# FMC130 Product Change Notifications

**Product change notifications (PCN)** is the way of informing customers of upcoming changes related to Teltonika products. This includes outward appearance adjustments, hardware improvements, firmware changes, changes to package contents, etc. This page stores information regarding changes to the FMC130 tracking device. Below you will find a list of both upcoming and already implemented changes sorted from newest to oldest (top to bottom).

## 2024.01.05: GNSS antenna changes

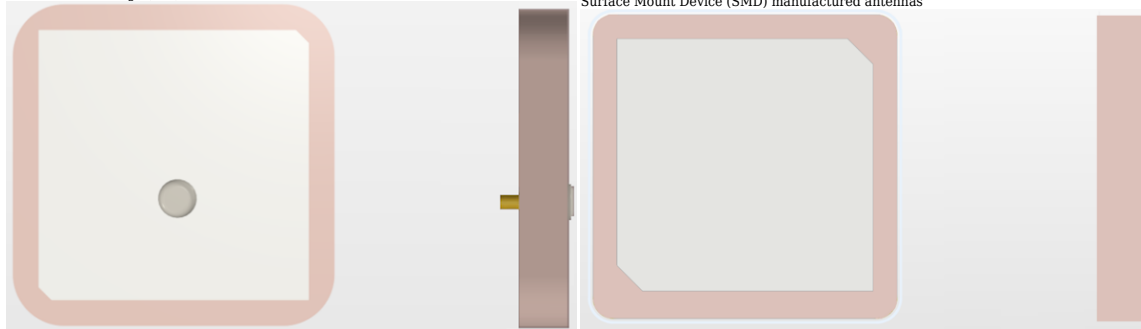
We would like to inform you that starting from February 2024, there will be a change in the manufacturing process of our FMC130 devices. We will be transitioning to utilize Surface Mount Device (SMD) manufactured GNSS antennas, which will replace the existing Dual-In-line Package (DIP) technique.

Change of the manufacturing process, transition from Dual-In-line Package (DIP) to Surface Mount Device (SMD) process.

Old version:

Dual-In-Line Package (DIP) manufactured antennas

New version:

Surface Mount Device (SMD) manufactured antennas

Antenna size: 25x25x4 mm  
Center frequency: 1575.42 MHz, 1602 MHz  
VSWR: <1.1  
Average Gain: -2.6 dB  
Return loss: <-25 dB

Antenna size: 25x25x4 mm  
Center frequency 1575.42 MHz, 1602 MHz  
VSWR: <1.9  
Average Gain: -2.5 dB  
Return loss: <-9 dB

Change reasons	Standardization of GNSS antennas throughout device portfolio and manufacturing efficiency improvements.	
Release date	February, 2024.	
<b>Affected products</b>		
Model	Affected order codes	Order code changes
FMC130	FMC130***** order codes	SMD manufactured antennas
<b>Change impact</b>		
Risk assessment	During transition period clients might receive devices with previous DIP manufactured antennas. The transition period can last from February to June.	
	Since the change of the GNSS antenna is visible visually on PCB, in order to avoid problems at the customs of certain countries, we suggest informing the relevant authorities about the change of the GNSS antenna. The new SMD GNSS antenna provides an equivalent track quality and performance level, as verified through testing. Testing results:	
	<b>Device    Antenna    Avg. Difference from precise track [m]*</b>	
	FMC130_211 SMD    3.30
